#412 / #618 HYDRAULIC SCHEMATIC

PART NO: 1822801
DESCRIPTION: #412/#618 HYDRAULIC SCHEMATIC

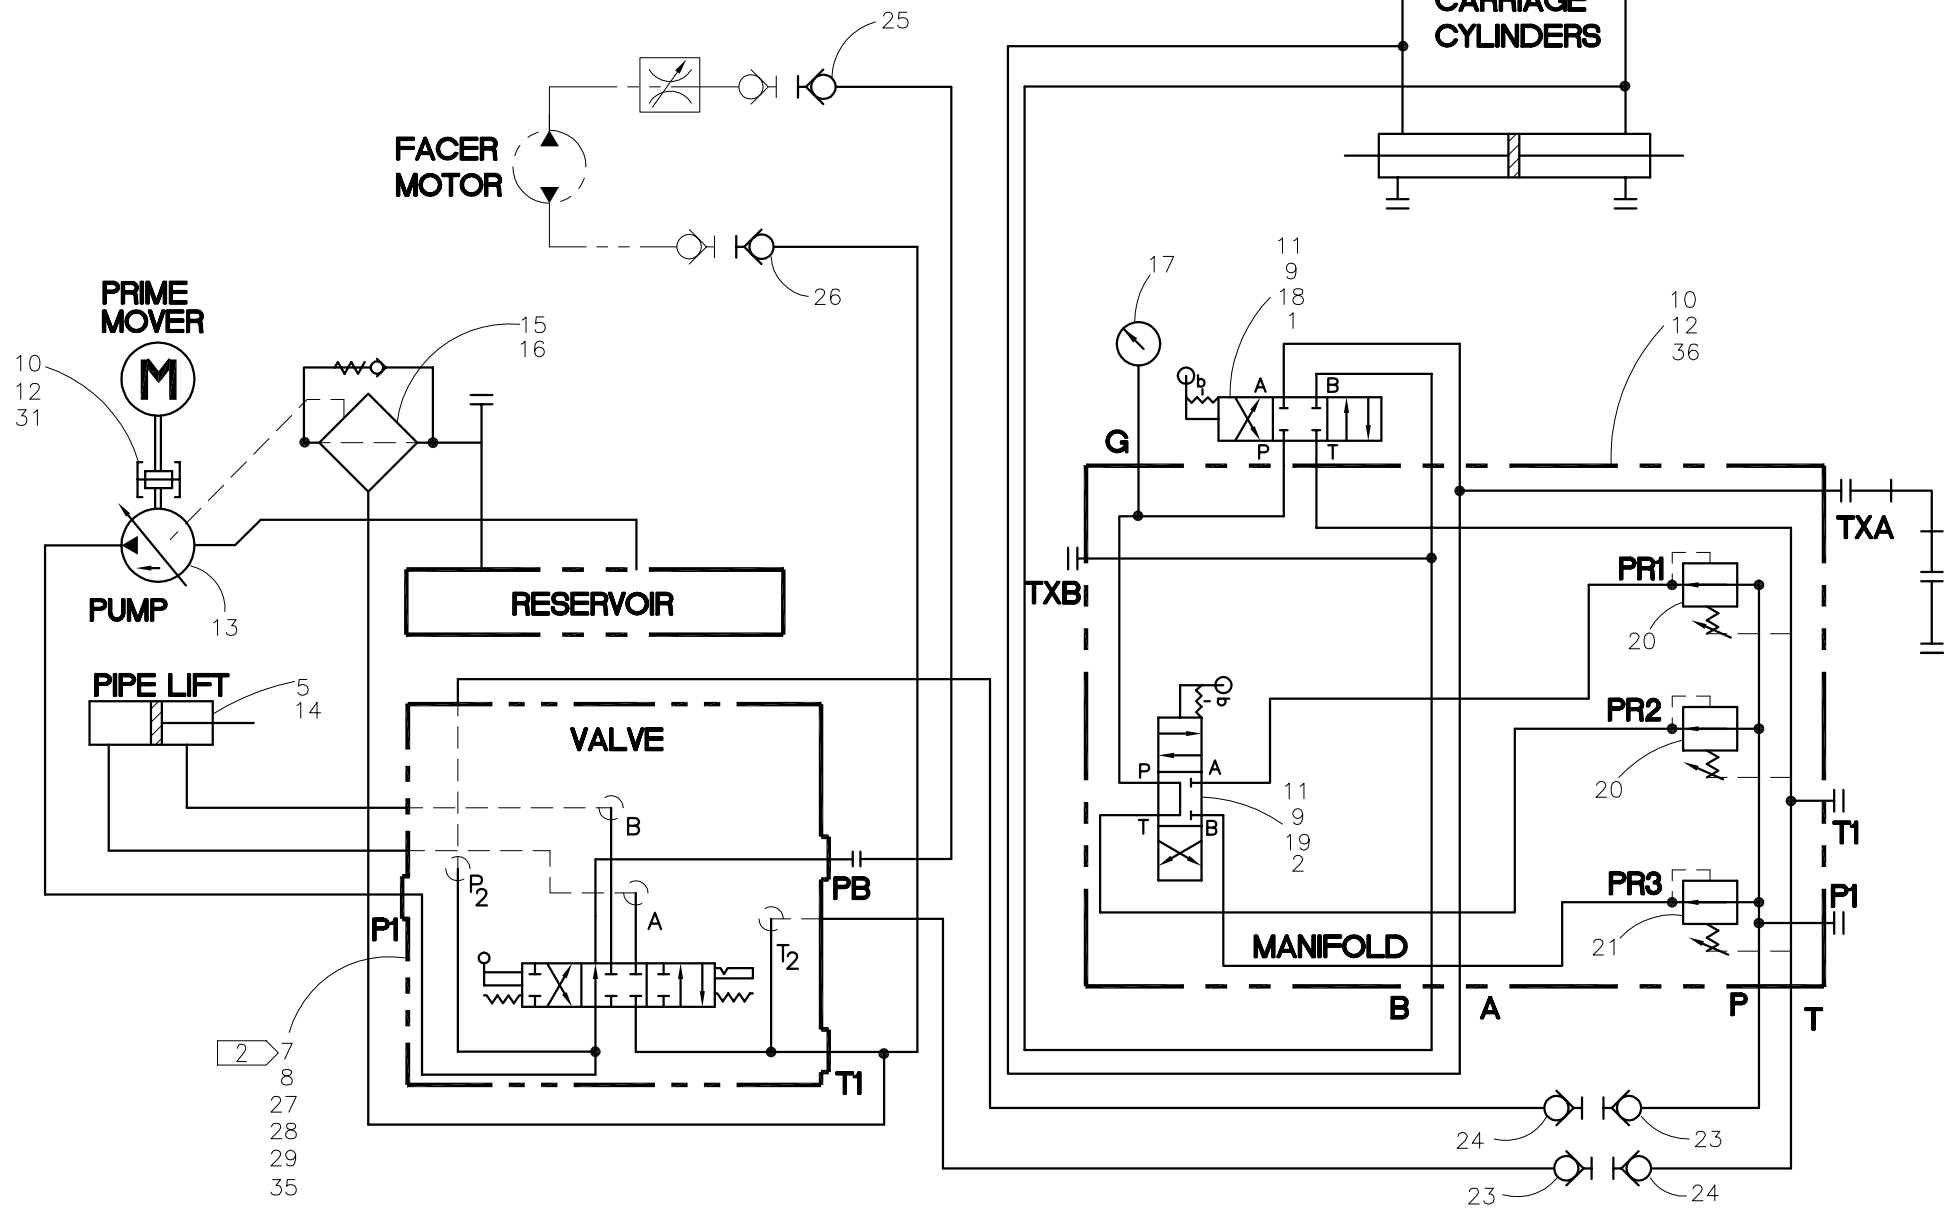
<u>APPR.</u>	<u>REV</u>	<u>DATE</u>	<u>BY</u>	<u>DESCRIPTION OF REVISION</u>
SWB	A	8/08/97	BB	REMOVED ITEM #1 816301 & ITEM #6 1814001, BECAUSE THEY WERE CONTAINED IN ITEM #36, ADDED ITEM #36 1814002. CORRECTED FILTER SYMBOL BY ADDING BY-PASS. RE-ARRANGED SCHEMATIC TO REPRESENT AS-BUILT CONDITION.
TLW	B	12/30/97	JPS	DREW DATA LOGGER FITTINGS @ PORT TXA. CORRECTED ITEMS 3 & 4 LABELS BY REVISING CALLOUTS ON DRAWING. MOVED CALLOUTS FOR ITEMS 9 & 11 TO VALVE CALLOUT FOR CLARITY.
DWP	C	6/2/99	MRP	REVISED ITEM #7 MEF00079 FROM A SPRING CENTERED VALVE TO A SPRING CENTERED VALVE WITH DETENT IN DOWN POSITION TO PREVENT BLEED OFF PRESSURE FROM RAISING PIPE LIFT. CREATED REPLACEMENT VALVE VALVE BOX LEVER MEF00114 FOR ALL UNITS PRIOR TO THIS REVISION.
TLW	-	7/22/99	MRP	REVISED ITEM #18 FROM MEF00013 TO MEF00085 AND ITEM #19 FROM MEF00014 TO MEF00086. TO ARON VALVES FOR PRIMARY SOURCE AND CONTINENTAL VALVES FOR REPLACEMENTS.

TLW	D	10/13/99	MLM	REMOVED ITEMS 3 & 4 (816330)(816331)NOT USED W/ARON VALVE. ADDED LABELS TO NOTE 1 TO BE INCLUDED WITH REPLACEMENT VALVE.
TLW	E	3/28/00	MRP	CORRECTED CALLOUT ON DRAWING FOR VALVES, ITEMS 18 AND 19. THEY WERE SWITCHED ON REV. A WHEN SCHEMATIC WAS REARRANGED TO AS BUILT.
SWB	F	8/14/01	RLE	ADDED MEF00077, VALVE HANDLE LEVER, QTY. (2) BECAUSE HANDLE NO LONGER COMES WITH VALVE.
SWB	G	2/14/02	ALK	CORRECTED QTY. ON ITEM 8 (MEF00077) FROM 2 TO 1. ADDED NOTE 2 TO CLARIFY VALVE HANDLE LEVERS MUST BE PURCHASED SEPARATELY.
SWB	H	07/29/02	BWW	REVISED TO REMOVE ITEM 2 816302 AND ITEM 22 MEI00001. CHANGED QTY OF ITEM 25 MFH00003 FROM 2 TO 1 AND ITEM 26 MFH00004 FROM 2 TO 1. PARTS MOVED TO 1834103 FACER HYDRAULIC/PLUMBING SCHEMATIC.
LAA	-	04/15/03	BWW	CHANGED ITEM 14 FROM MEB00104 TO MEB00128 TO INCORPORATE CARLSON WELDED CYLINDER.
SWB	J	01/07/04	BWW	REVISED ITEM 18 MEF00085 TO MEF00013 AND ITEM 19 MEF00086 TO MEF00014. ADDED NEW ITEMS 1 816330 QTY 1 AND 2 816331 QTY 1. REMOVED NOTE 1 FOR VALVE REPLACEMENT PARTS. CHANGES MADE DUE TO PHASE OUT OF ARON VALVES TO CONTINENTAL.
